Department of Energy
Washington, D.C. 20545

Docket No. 50-537
HQ:S:82:065

RESPONSES TO REQUEST FOR ADDITIONAL INFORMATION

Reference: Letter, P. S. Check to J. R. Longenecker, "CRBRP Request for Additional Information," dated April 30, 1982

Figure 5.6-8 PROTECTED AIR-COOLED CONDENSER

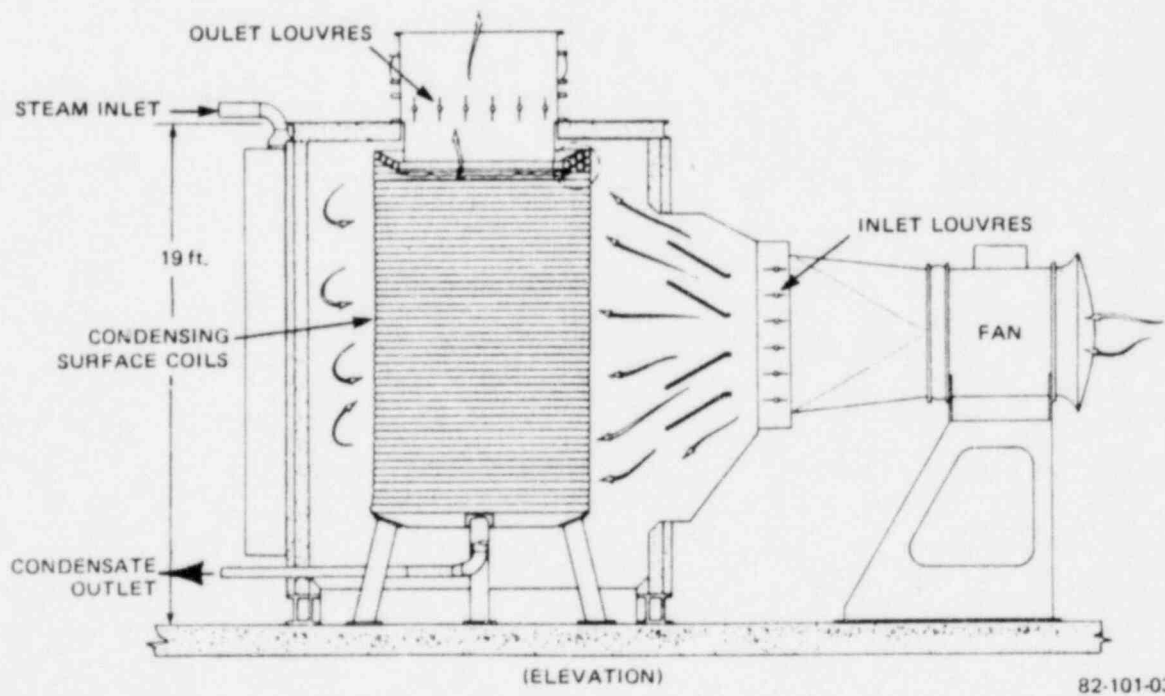
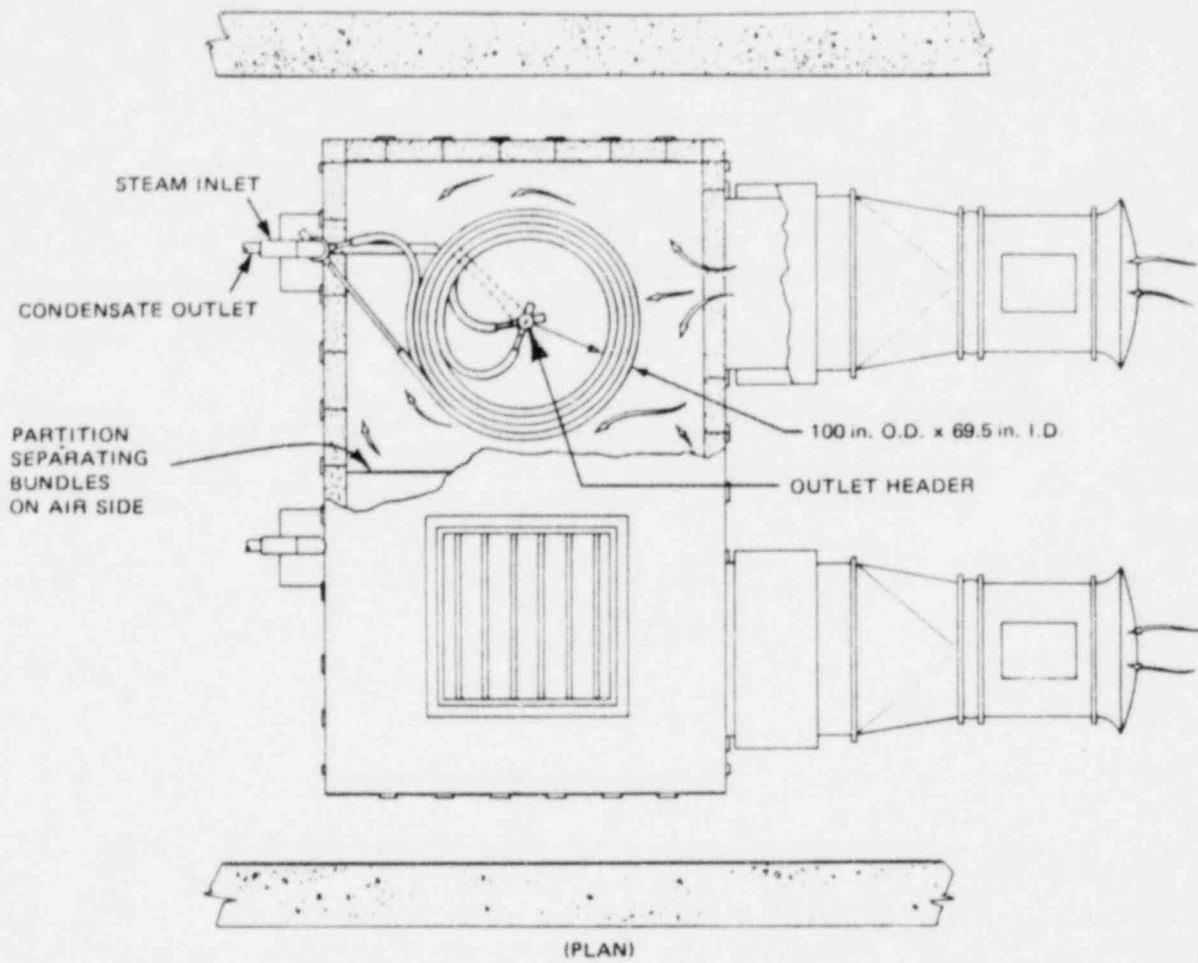
Question QCS760.116

Each tube bundle consists of 50 finned tubes connected in parallel between vertical pipe headers. Each tube is approximately 100 ft. long and, of the 100 ft. length, 95 ft. is finned. The individual finned tubes are formed in a conical spiral of approximately four concentric turns with a slope toward the center. The tubes are connected in parallel between vertical pipe headers. The inlet header is on the outside and outlet header is in the center of spiraled coils. The finned tubes are made of 2 inch O.D. tubes with 0.156 inch minimum wall as shown on Figure 5.6-10. The O.D. of the fin is 3.28 inches. The fins are serrated into 0.156 inch segments from continuous strip 0.050 inch thick x 0.75 inch wide. The strip is first formed into the shape of an "L". The strip is then wound around the tube O.D. to complete the footed fin attachment to the tube. There are two separate tube bundles in each PACC.

Three PACC units are provided, one for each heat transport loop, each capable of removing the total decay heat approximately 1 hour after shutdown. Each unit is single active failure proof in that no single active failure will result in the loss of more than 50% of heat removal capability. This is provided by utilizing two tube bundles, two fans, etc., such that at least half capacity is retained following the failure. The PACC unit is a Seismic Category I design, hardened against tornado missiles and designed to withstand the pressure loads from tornados. The PACC tube bundle design is based upon standard techniques for steam-to-air heat exchangers.

The range of automatic operation is from 15% to 100% heat rejection. From 100% down to approximately 30% (4.5 MWt) the unit is operating in the first mode, and from 30% to 15% in the second mode. Control is accomplished by sensing and maintaining the steam pressure at the desired set point.
